MIL-R-83536/22
AMENDMENT 4
15 June 1999
SUPERSEDING
AMENDMENT 3
30 September 1996

MILITARY SPECIFICATION SHEET

RELAYS, ELECTROMAGNETIC, ESTABLISHED RELIABILITY, 3PDT, LOW LEVEL TO 10 AMPERES, PERMANENT MAGNET DRIVE, HERMETICALLY SEALED, ALL WELDED, TRANSIENT SUPPRESSED DC COIL

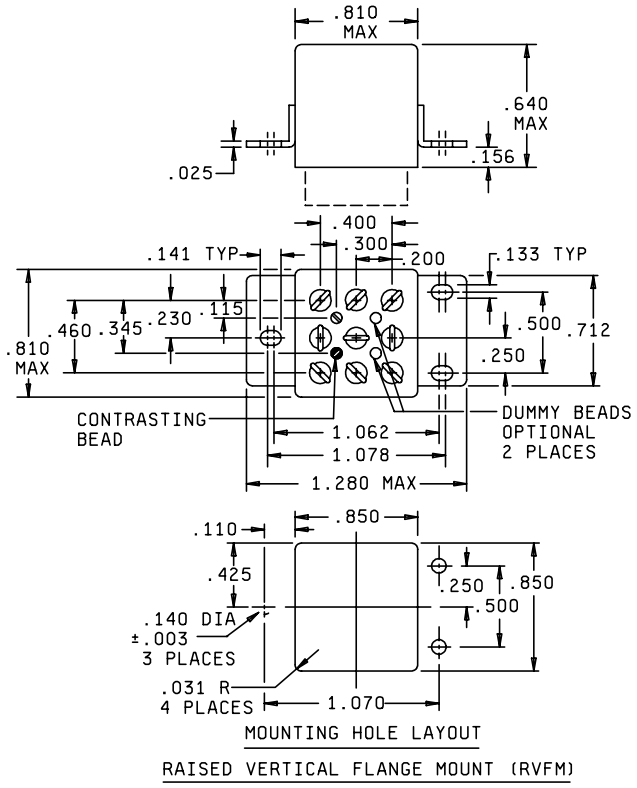
PAGE 2

* FIGURE 1, delete and substitute:

TRACK MOUNT

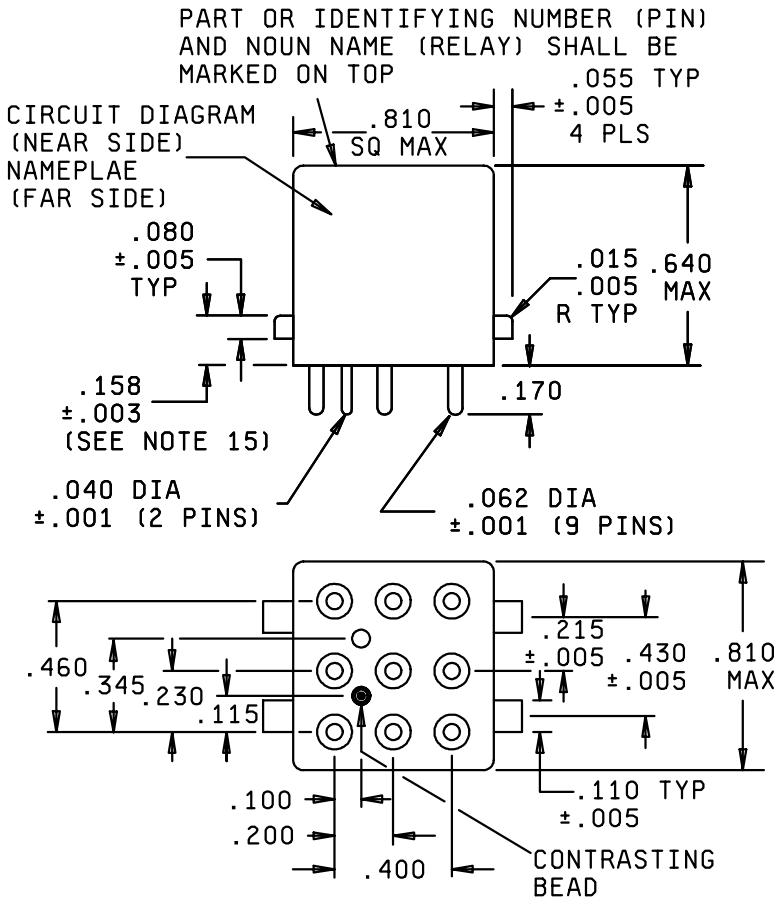
PAGE 4

* FIGURE 1, delete and substitute:

CIRCUIT DIAGRAM
(ALTERNATE INTERNAL
DIODE CONFIGURATION)

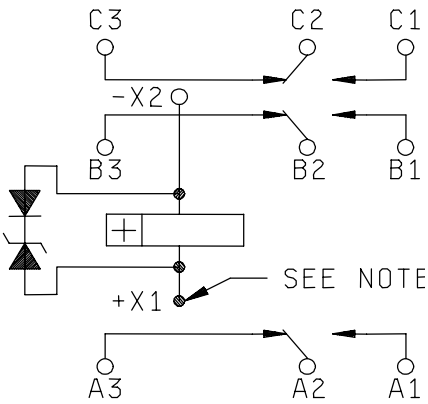
FIGURE 1, above figure title: Add "CIRCUIT DIAGRAM".

FIGURE 1, add the following circuit diagram:
